SUBJECT: Application for amend to License DPR-74, revising Tech Specs re steam line break analysis.

Donald C. Cook Nuclear Plant Unit 2  
Docket No. 50-316  
License No. DPR-74  
STEAM LINE BREAK ANALYSIS  
TECHNICAL SPECIFICATION CHANGES

Reasons and 10 CFR 50.92  
Significant Hazards Evaluation  
for Changes to the  
Technical Specifications for the  
Donald C. Cook Nuclear Plant Unit 2

FIGURE 1

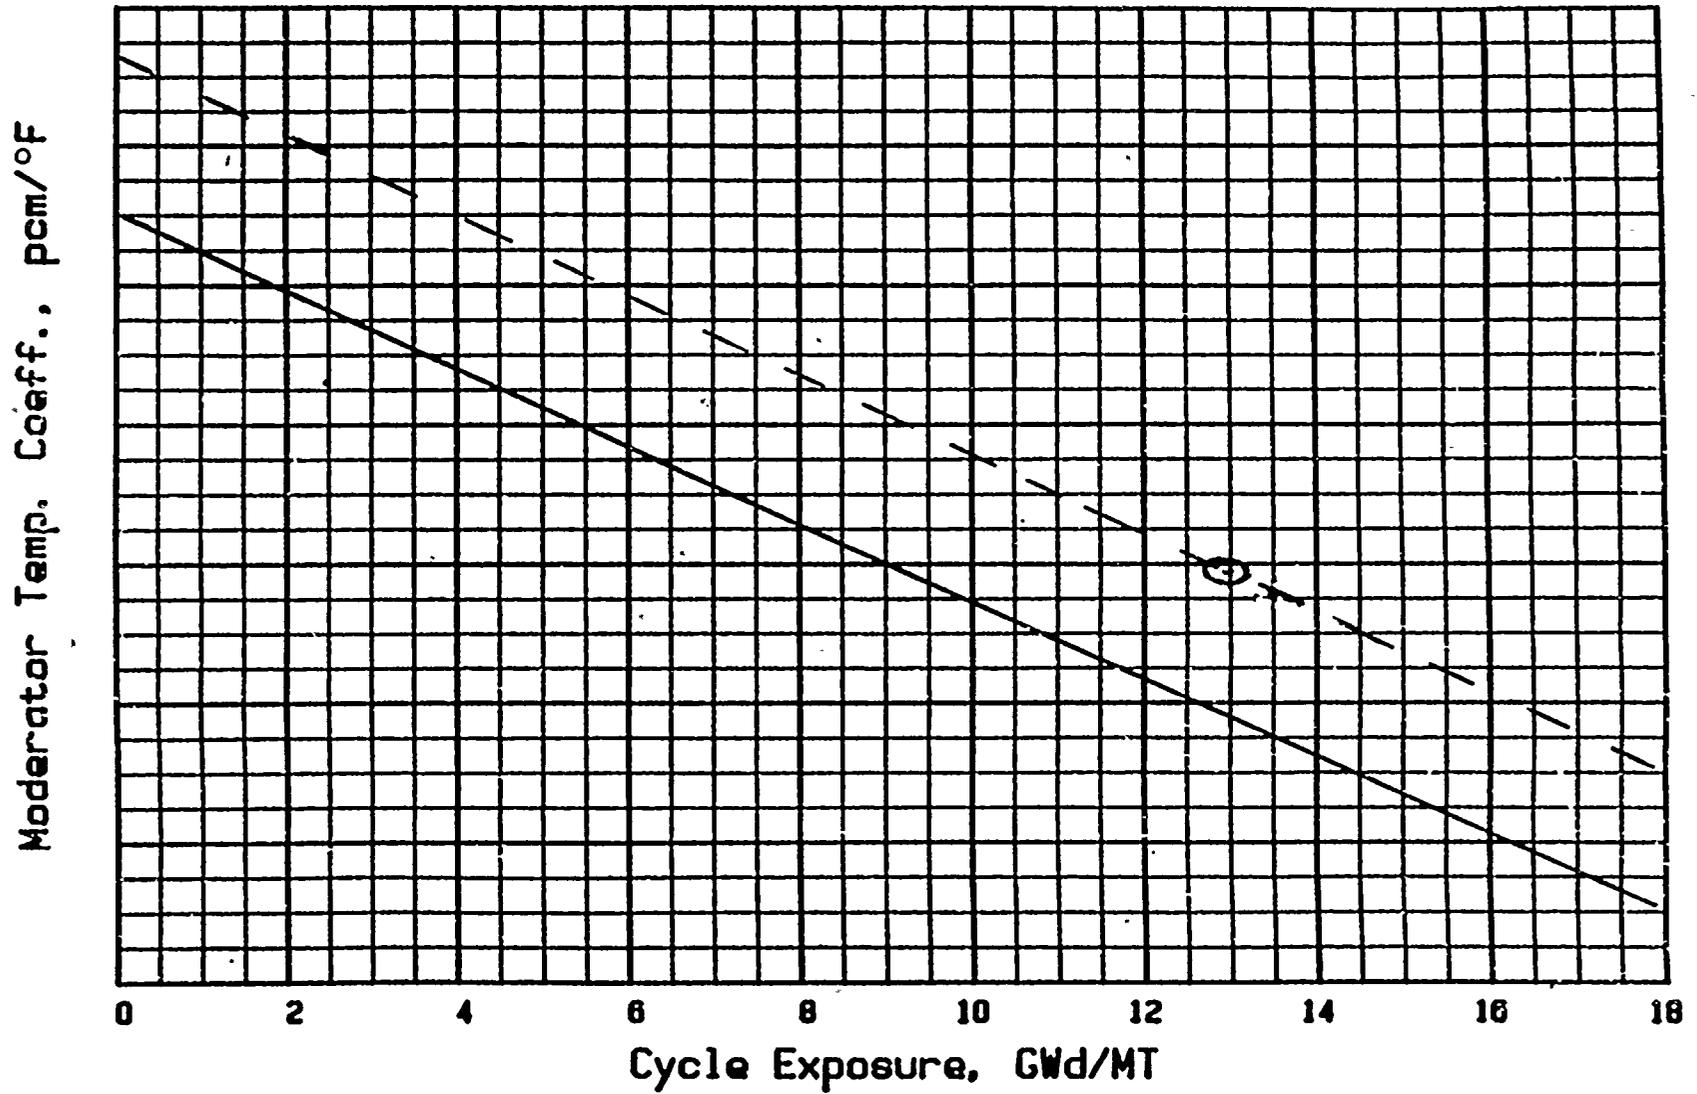
Extrapolation of the measured MTC at 300 ppm is achieved using cycle design data provided by the fuel vendor. The predicted MTC as a function of exposure is illustrated in Figure 1. (The curve is from Unit 2 Cycle 6). The 300 ppm measured value is extrapolated to the EOL exposure, using the same shape as the design curve.

As an example, the measured MTC for Unit 2 Cycle 6 was  $-1.67 \times 10^{-4} \Delta k/k/^\circ F$  normalized to hot full power, all rods out, 300 ppm boron concentration conditions. Extrapolation of this data, as shown in Figure 1, yielded a predicted MTC value of  $-2.23 \times 10^{-4} \Delta k/k/^\circ F$  at EOL. This value is compared to the limit of  $-3.5 \times 10^{-4} \Delta k/k/^\circ F$ . As can be seen, there is a substantial margin between the extrapolated MTC and the EOL limit.
